# Tivoli MFG Ltd.

## Service Bulletin

Bulletin No: SOSR001

Purpose: Reservoir installation for Spin Out Base Gearboxes

Drawing# SOSA010E

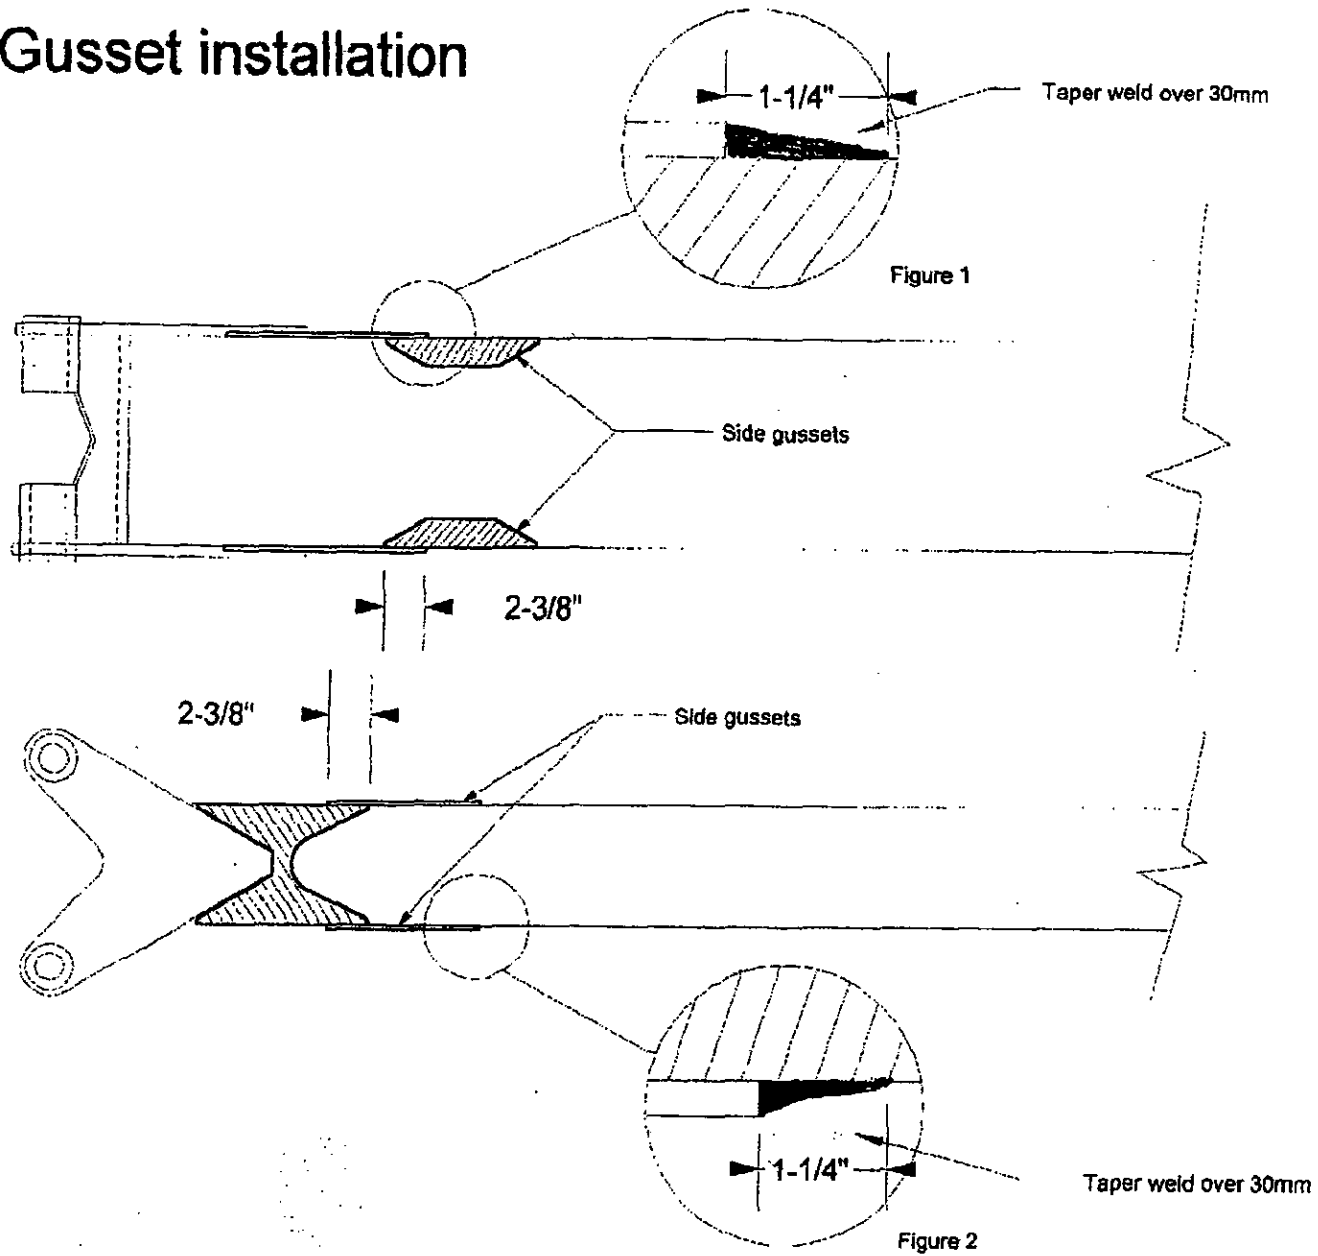
- Step 19: Taper weld from side point of top plate to side gusset as described in figure 1 drawing SOSA010E.
- Step 20: Taper weld at end of side gusset as described in figure 2 drawing SOSA010E.
- Step 21: Dress and sand all welds.
- Step 22: After all work is completed, paint sweeps, reassemble ride and completely inspect and test as outlined in the operators manual before opening to public.

<b>Tivoli Mfg. Ltd.</b>	Description <b>Sweep Out Sweep</b>	Part <b>Sweep side Gusset</b>	Drawing# <b>SOSA010D</b>	Date <b>02-22-03</b>
-------------------------	---------------------------------------	----------------------------------	-----------------------------	-------------------------

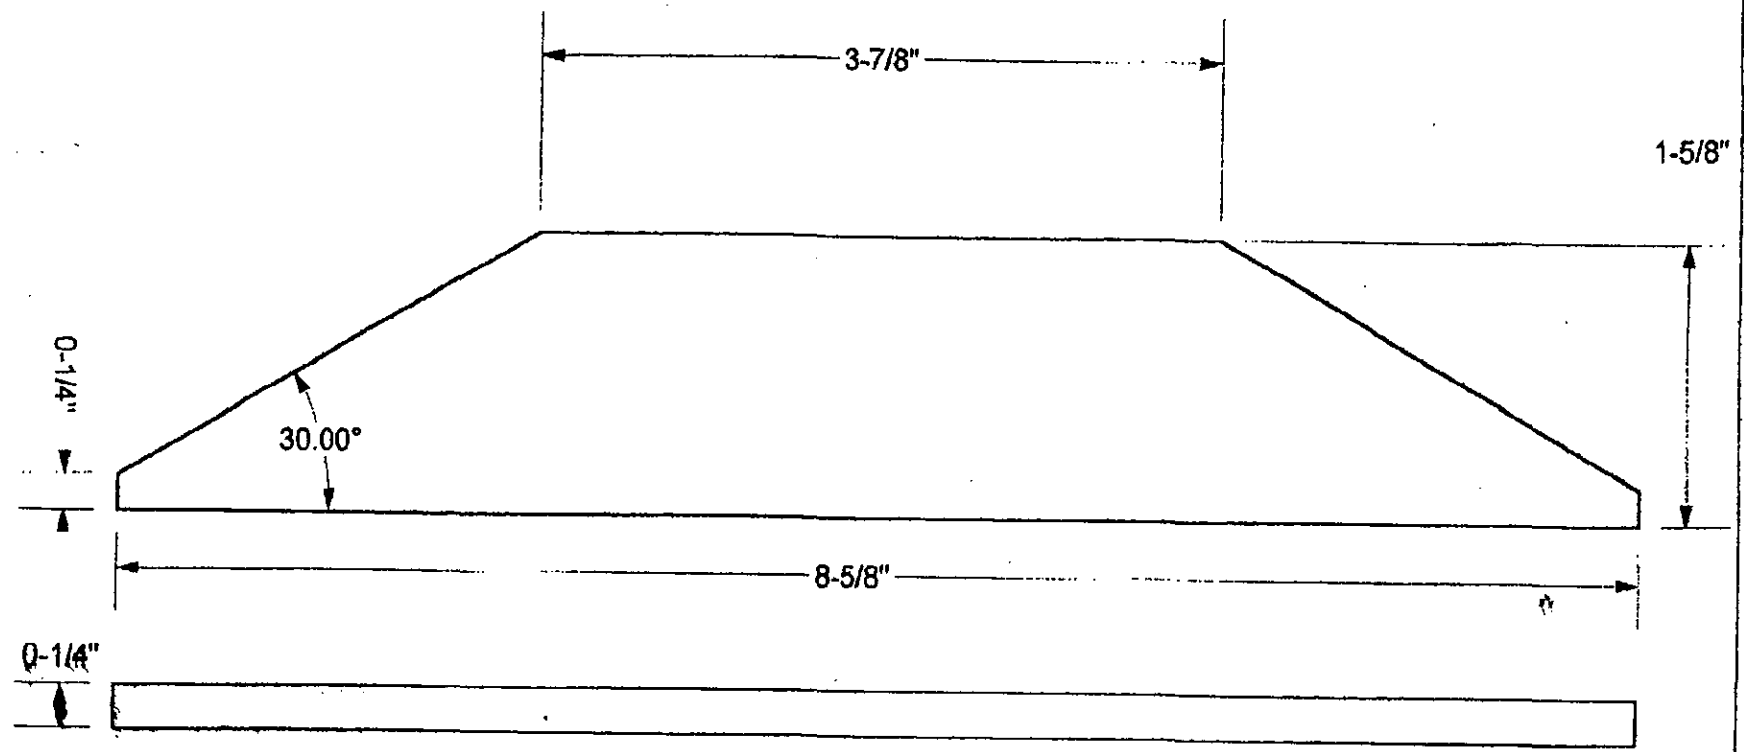
- Step 16: Clean side of sweeps of paint where welding will take place.
- Step 17: Position plates on side of sweep as described in drawing SOSA010D and tack n place.
- Step 18: Weld gusset in place with a 1/4" fillet weld on all sides.

Figure A

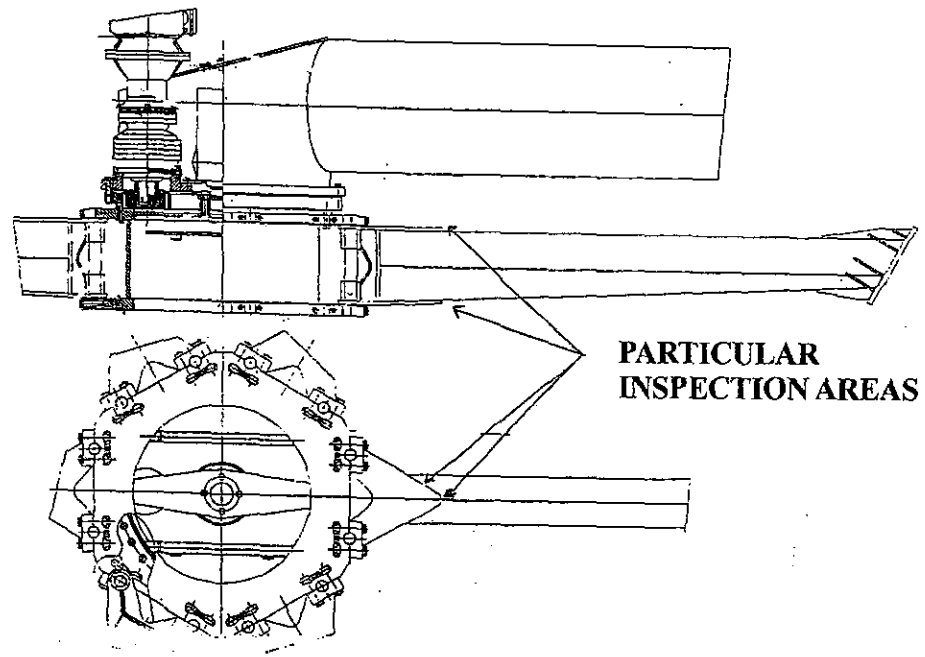
2. Immediately inspect all welds on the "Spin Out" sweep arms as indicated on the attached drawings. Be sure to visually inspect the full sweep length, and make appropriate repairs if necessary. Pay particular attention to the hinge plate gussets and the gussets and the tips of the gusset kits (Drawing A).

Figure B

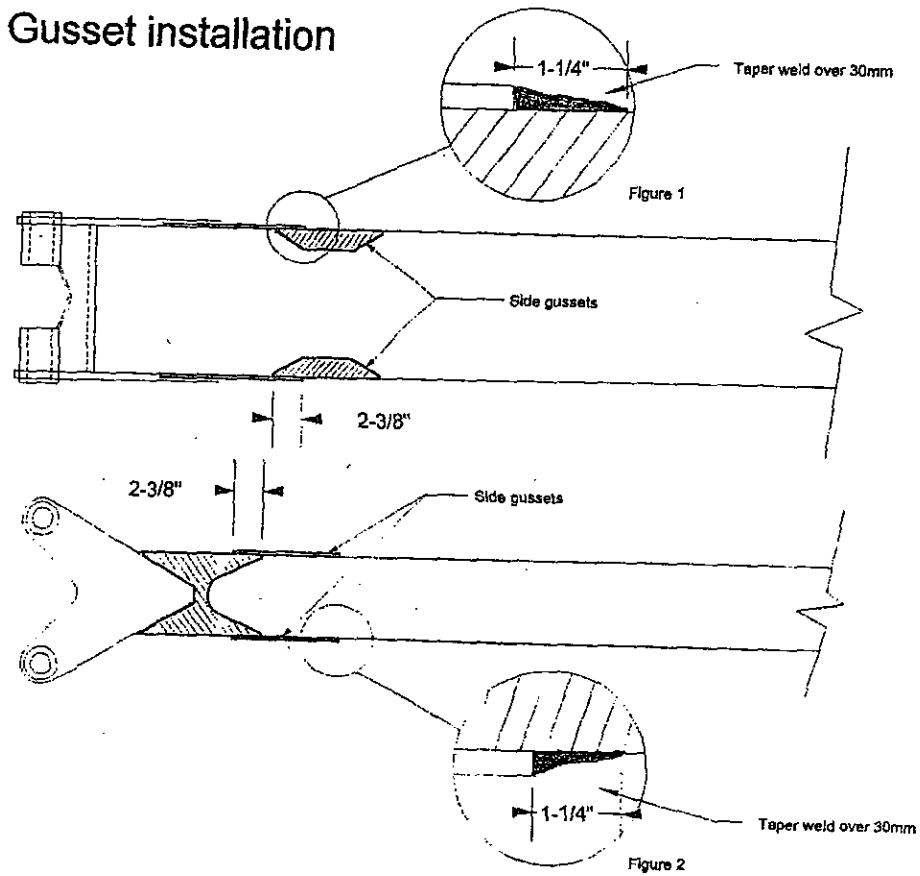
5. Inspect the gusset welds every 200 hours of operation or 6 months, whichever comes first with particular attention to the tips of the gusset kit as indicated in the attached drawing. (Drawing B). These inspections shall be performed by a certified inspector, with written documentation of that inspection maintained by the ride owner/operator.

<b>Tivoli Mfg. Ltd.</b>	Description Spin Out Sweep Arm Pin	Part Safety/qualification.	Drawing# SOSA014A	Date 12-10-04
-------------------------	---------------------------------------	-------------------------------	----------------------	------------------

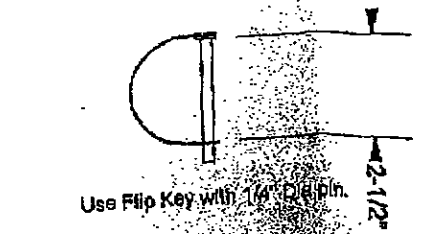
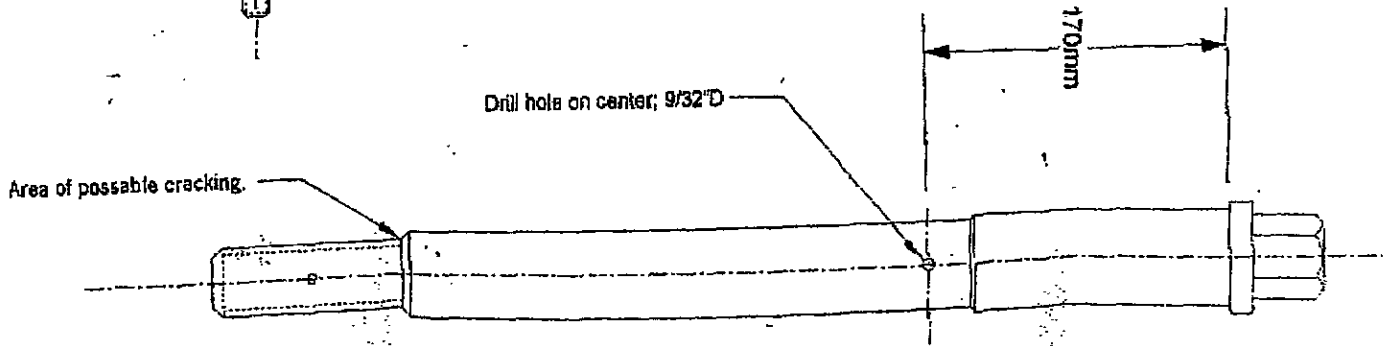
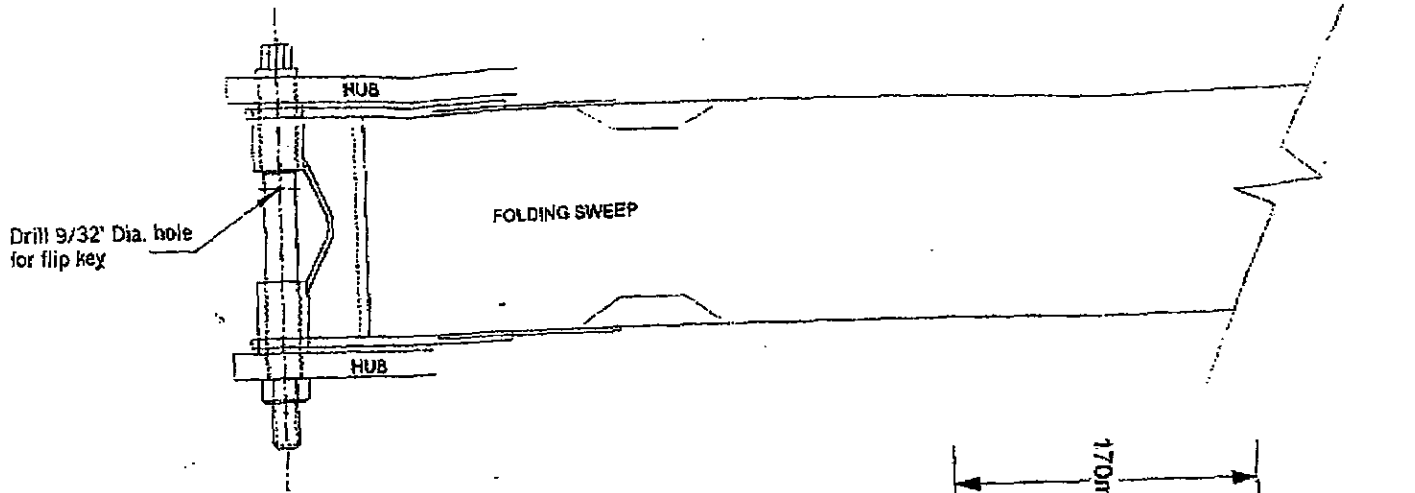
It has come to the attention of Tivoli Mfg. Ltd. that severe sweep pin bushing wear or abuse of removable sweep pins can cause these pins to crack or possibly break at the point where the threaded portion of the pin meets the shaft (see attached drawing SOSA014A for location). Even though there is an annual NDT requirement on these pins (Safety Bulletin SOSA009) Tivoli now requires the addition of a safety key to insure this pin remains in place in the remote case of pin breakage.

As illustrated on the attached drawing a 9/32" hole is to be drilled in the center of the 4 removable pins, 170mm from the underside of the head of the pin. The hole is to be deburred to remove any sharp edges.

During ride operation a 1/4" x 2- 1/2" Flip Key, as described in accompanied drawing, must be inserted through the hole and clipped in place. The key presently being inserted in the threaded area of the pin is still required.
